Annex 8

Pure and hybrid electric vehicles

Comments of Iddo on Annex 8 (chapter 4) and Task Force Drafting Answer/Proposal

Figure A8/1
Possible test sequences in case of OVC-HEV testing

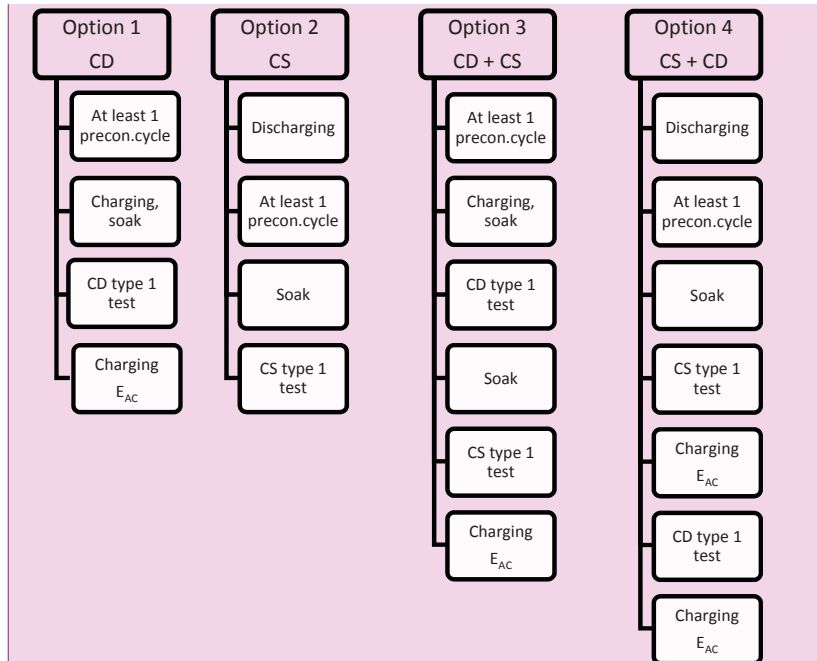
Comment [DTF17]: "Test" replaced by "Type 1 test"
→ Justification: clear and understandable (bijjective) description

Figure A8.App1a/1

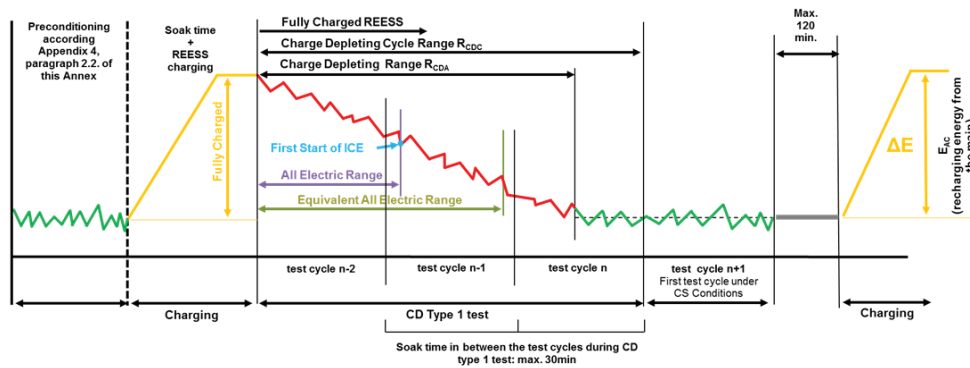
Comment [te125]: How is this determined? Compare with Figure A8 App 1a/1.

Comment [DTF126]: Is the distance travelled in the transient cycle $\rightarrow \sim 23.3$ km

Figure A8.App1b/4

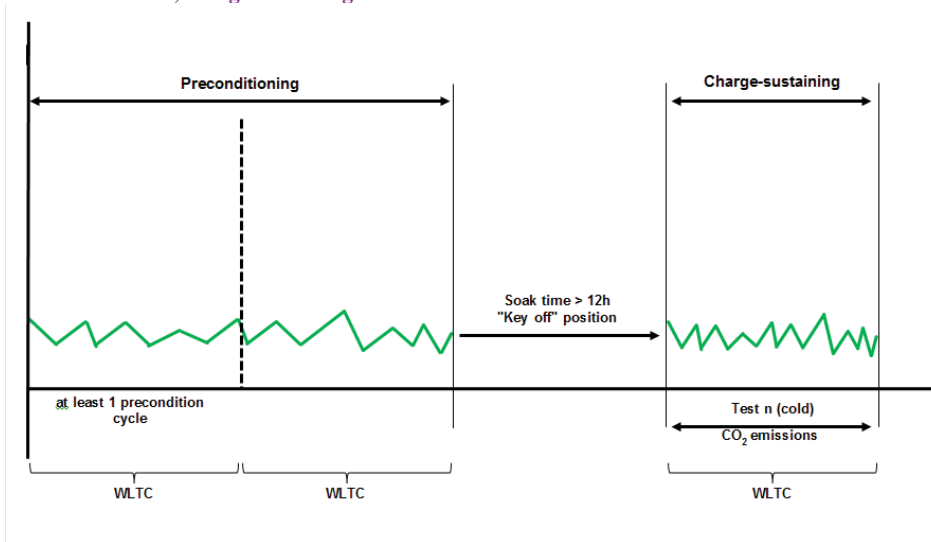
Comment [DTF77]:
Check Soak Time > 12h?!?!?
